Application No.: 10/797,347

Docket No.: MOLLO 3.0-001

REMARKS

In order to further assist the Examiner in understanding this interpretation, Applicant presents the following FIGS. A and B.

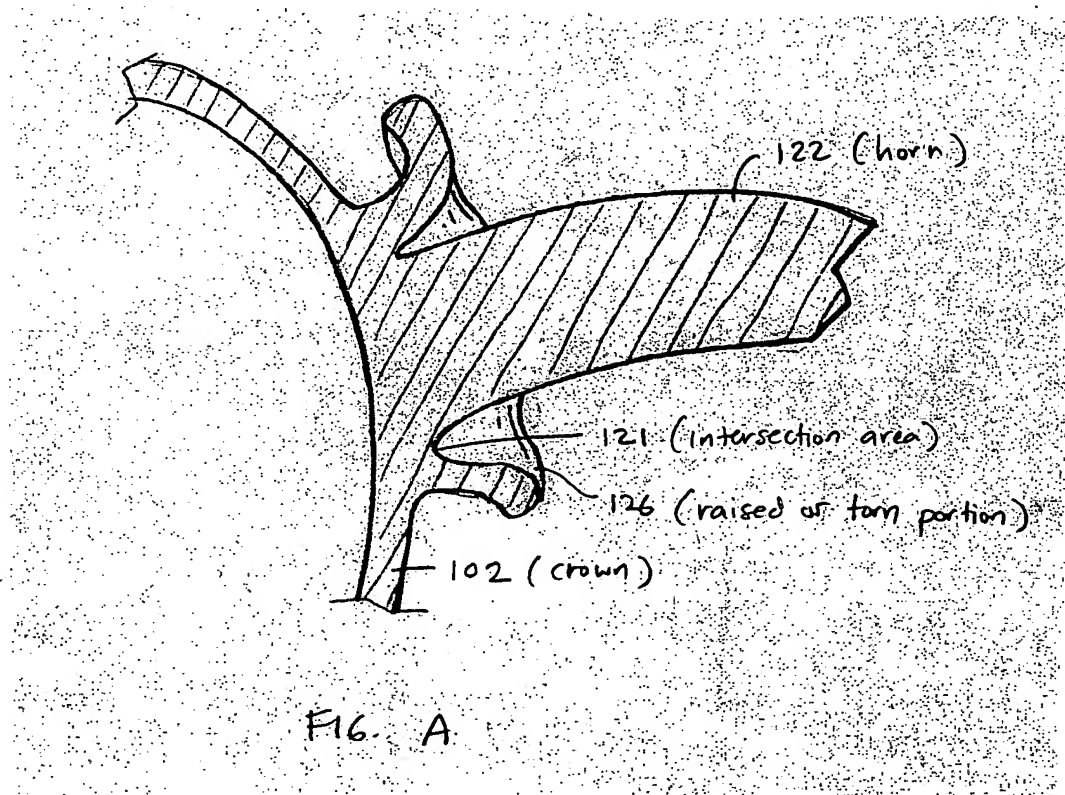
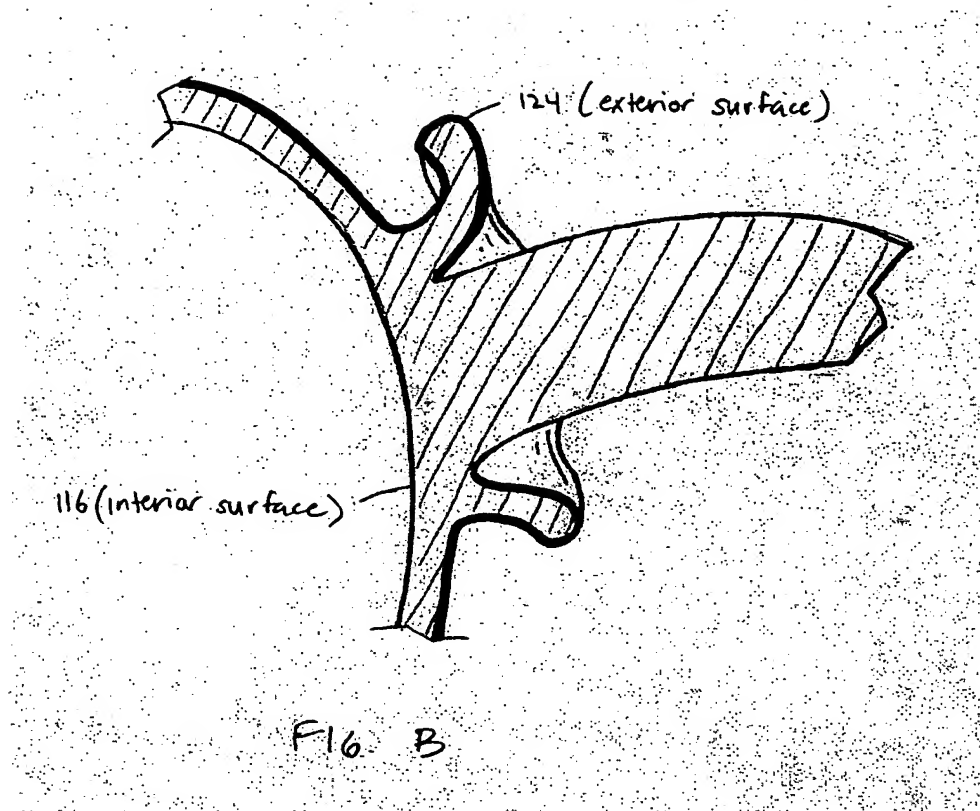
In paragraph 3 of the Official Action, the Examiner objected to the drawings under 37 C.F.R. § 1.83(a) for failing to depict each feature of the claimed invention. Specifically, the Examiner indicated that the intersection areas or attachment areas set forth in claims 2, 14-16, 21, 27, and 32 must be shown or the features cancelled from the claims.

FIGS. 1-4 have been amended to more clearly depict the annotation of reference numeral 121, corresponding to the intersection area. For example, FIG. 2, which previously did not depict annotation for reference numeral 121, has been amended to now include such an annotation. As shown clearly, the intersection area 121 in FIG. 2 is "where the horn meets the crown", as described in paragraph [0104].

As shown in FIG. A, the horn 122 extends from the crown 102 from an intersection area 121. The intersection area is formed at the intersection of the horn and the crown. The crown also includes a raised or torn portion 126 which extends above the intersection area. In FIG. B, the exterior surface 124 of the crown has been enhanced for clarity. It is clear in FIG. B that the exterior surface of the crown and the horn meet at an intersection area.
